# Sequoyah Nuclear Plant

## Steam Generator Replacement Project Topical Meeting

TVA/NRC Meeting

October 24, 2002

Figure 7-3 – Finite Element Model "SGE1" and "SGE2" and Element Groups and Global Coordinate Systems (Reference 6)

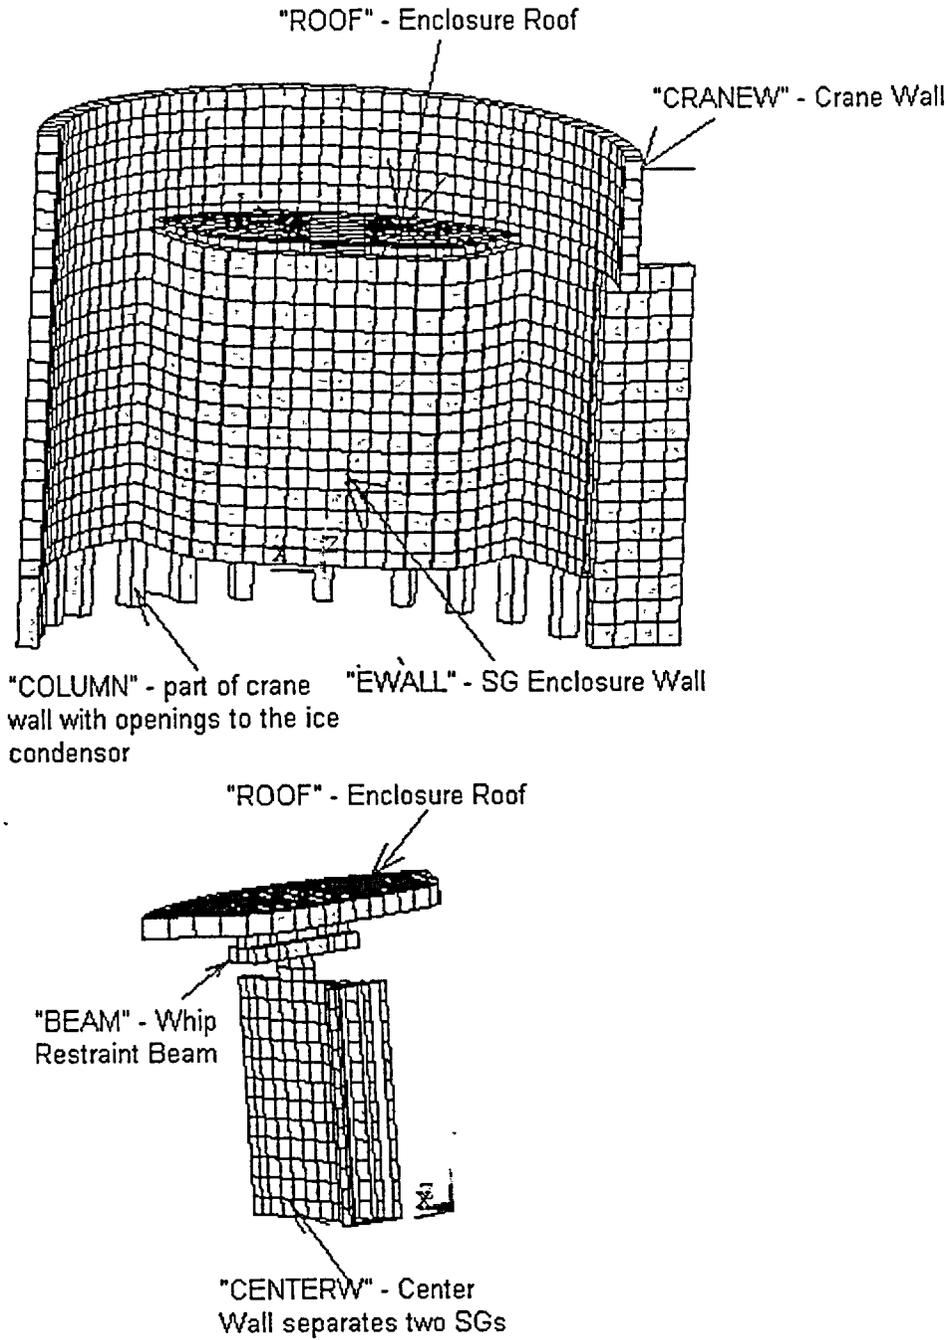
39. On page 27 the report states that "[t]he nodes at the cut-line along which the splice-plate connections are located were realistically modeled to transmit vertical forces and in-plane compression only." Was a zero force assumed in the vertical direction to be taken by the grout? If not, provide the justification on the amount of force in the vertical direction to be attributed to the grout.

*As stated in the report and discussed in response to Question 34 above, the nodes along the cut-line are modeled to transmit vertical forces and compression only. The grout is not considered to resist any forces other than compression so that there is zero shear force resisted by the grout.*

Figure 3. Bar-Lock Coupler Cutaway View Showing Internal Details

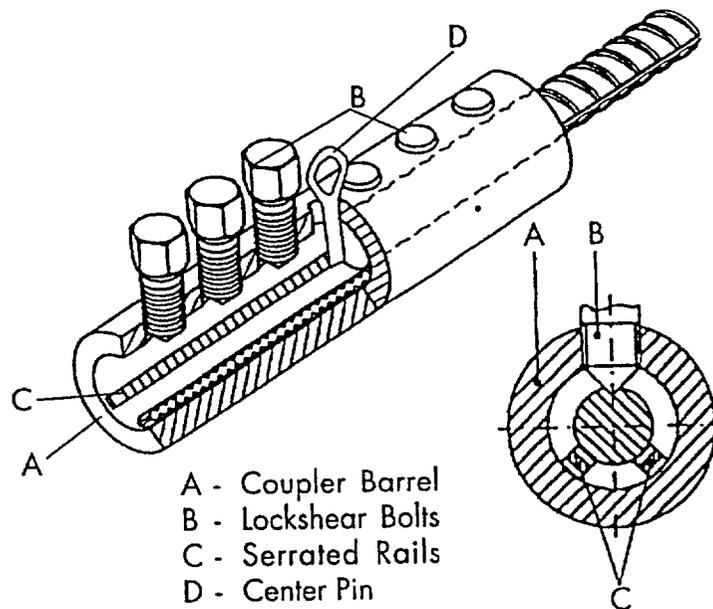
1. Provide a copy of the Bechtel/INEEL test report for the Bar-Lock Mechanical Splices. The report should include information on who performed the splice tests, their qualifications, and how the tests were performed.

The component parts of each Bar-Lock coupler consist of a steel tube, "lock-shear" bolts, and serrated rails. Figure 3 (4-1) shows a schematic diagram of the coupler design. The seamless, hot-rolled steel tube conforms to ASTM A-519, with a minimum tensile strength in excess of 100 ksi. The lockshear bolt material is AISI 41L40. The bolts are through-hardened over the entire bolt length and further induction-hardened at the conical bolt tip. The serrated rails are made of ASTM CD1018. They are machined and then carburized to a depth of 0.032 in.
